COLLINSVILLE OPEN CUT

11 September 2026

We refer to the Department of the Environment, Tourism, Science and Innovation (DETSI) Information Request (IR) dated 22 July 2026 for the Environmental Authority (EPML00332013) (EA) amendment application in relation to the Kerale Area Domain. The EA is for the Collinsville Open Cut (COL), owned and operated by NC Coal Company Pty Ltd (NC Coal).

FIGURE 2-1 CONCEPTUAL SITE MODEL DIAGRAM FOR THE KERALE AREA DOMAIN

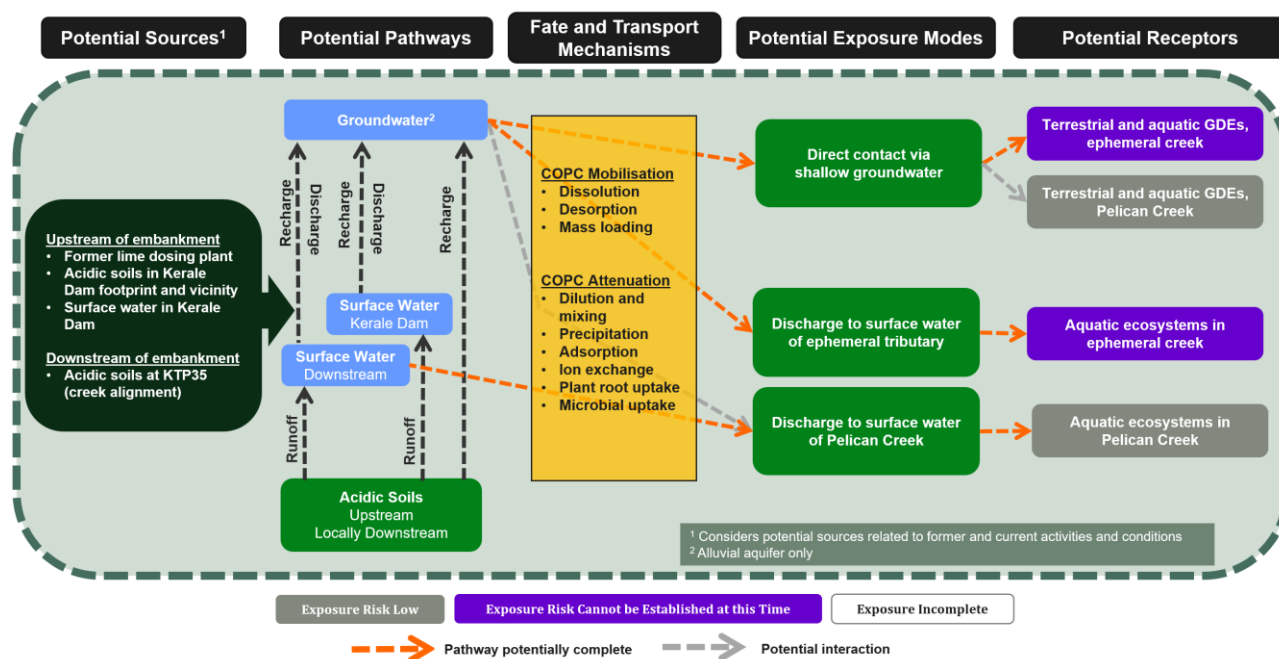
Provide information on the mechanisms incorporated into the conceptual site model.

Provide an updated conceptual site model that incorporates all relevant mechanisms, including, but not limited to, ion exchange, ion adsorption, precipitation, dissolution, dilution, microbial uptake, plant root uptake, desorption, mass loading.

Collectively, the available soil, sediment, surface water and groundwater data support a conceptual model in which the historical lime dosing facility is the primary source of acidity, and several secondary sources of contamination also exist. Within the Kerale Area Domain, these comprise the water, soils and sediments within Kerale Dam, as well as the seepage zone immediately downstream of the dam, which have been impacted by contaminants released from the historical lime dosing facility. The updated CSM diagram is provided in Figure 2-1.

The original CSM presented by ERM 2026b has been updated as shown in Figure 2-1. It incorporates information on the principal geochemical, hydrological and biological mechanisms influencing the mobilisation, transport, attenuation and fate of COPCs within the Kerale Area Domain.

The CSM identifies dissolution of secondary sulfate minerals within soils and sediments associated with the former lime dosing facility footprint and drainage line as a primary mechanism driving the release of acidity, sulfate and dissolved metals to surface water and shallow groundwater systems. Information has also been incorporated on precipitation of secondary mineral phases, which may temporarily attenuate dissolved constituent concentrations, and ion adsorption, desorption and ion exchange processes within soils, sediments and alluvial materials that may either attenuate or remobilise dissolved constituents under changing geochemical conditions.

FIGURE 6-1 WATER QUALITY MONITORING LOCATIONS NEAR THE KERALE AREA DOMAIN

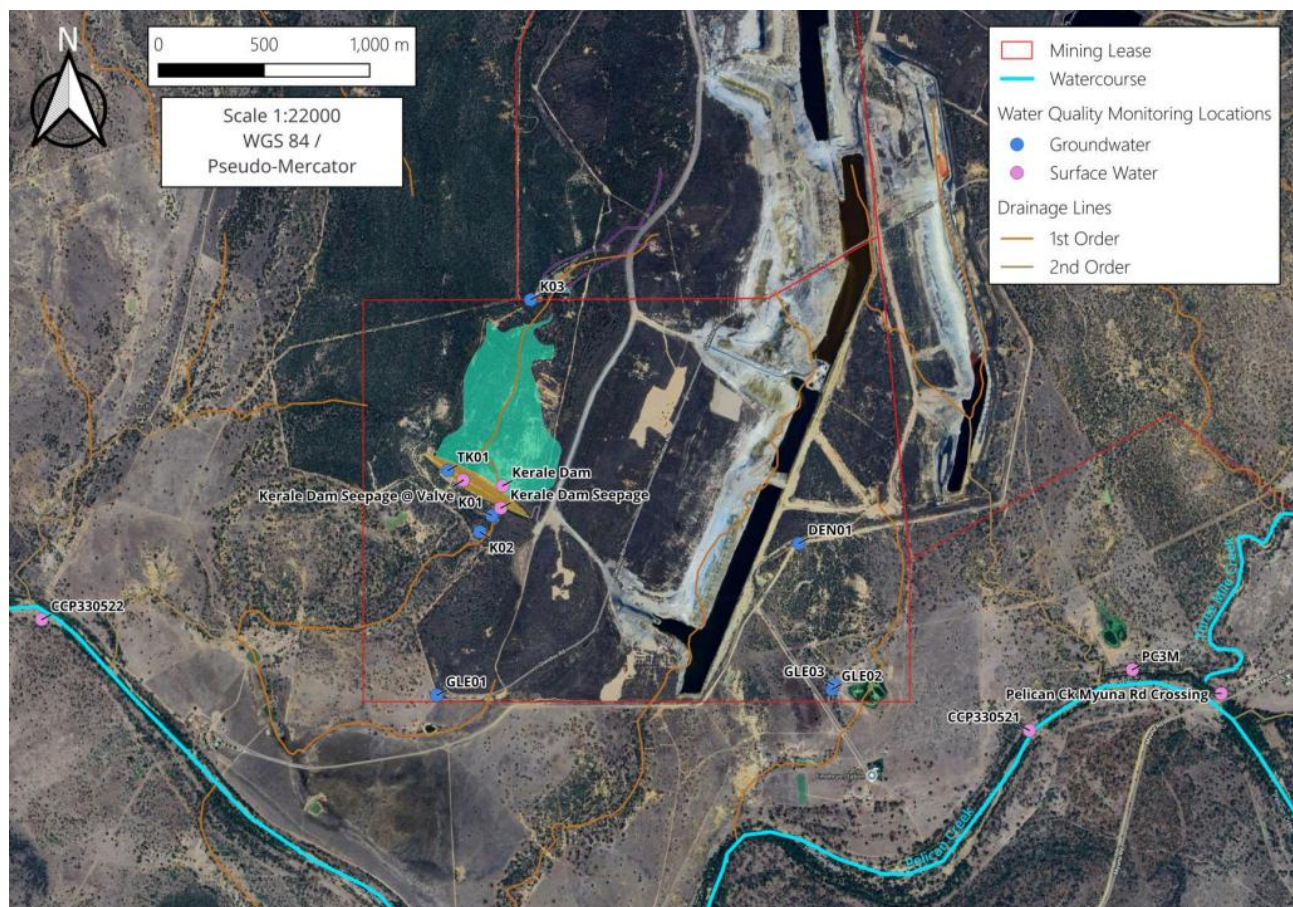
Provide an assessment and interpretation of the ionic composition between surface water, groundwater, seepage, and pits in the vicinity of the Kerale Area Domain.

The available ionic composition data indicates the former lime dosing facility, Kerale Dam surface water, acidic seepage location and shallow groundwater immediately downgradient of the embankment form a sulfate-rich and acidic geochemical system. The decrease in acidity and dissolved aluminium from K01 to K02 indicates attenuation along the shallow groundwater flow path. Groundwater at GLE01, located at the southern boundary of ML1064 and Pit 11 spoil porewater has a different ionic composition when compared to K01 and K02 distinguishing these locations from the acidic waters associated with the former lime dosing facility and Kerale Dam.

FIGURE 7-1 HISTORICAL IMAGERY OF THE KERAL AREA DOMAIN.

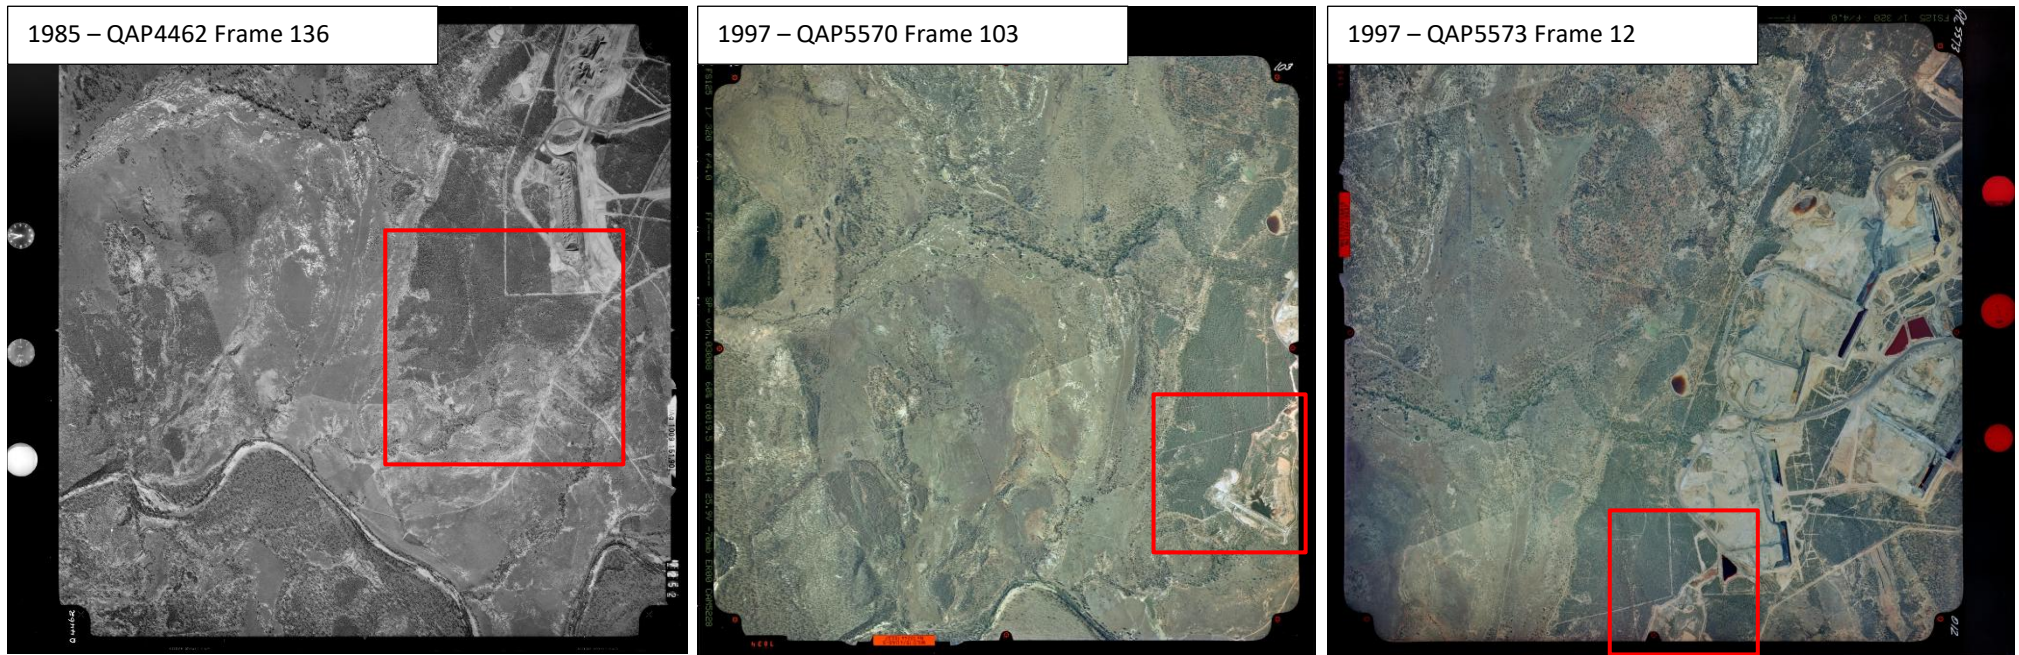
Provide the date of construction of the western and eastern diversion landforms.

Figure 7-1 demonstrates that the diversion landforms were constructed between 1985 and 1997. Maintenance of the diversion landforms has continued through time with their location being as per original construction.

Therefore, more specifically, it is estimated that the diversion landforms were constructed at some point between 1991 and 1997. This timeframe coincides with the approximate construction of the lime dosing facility in the early-mid 1990s.
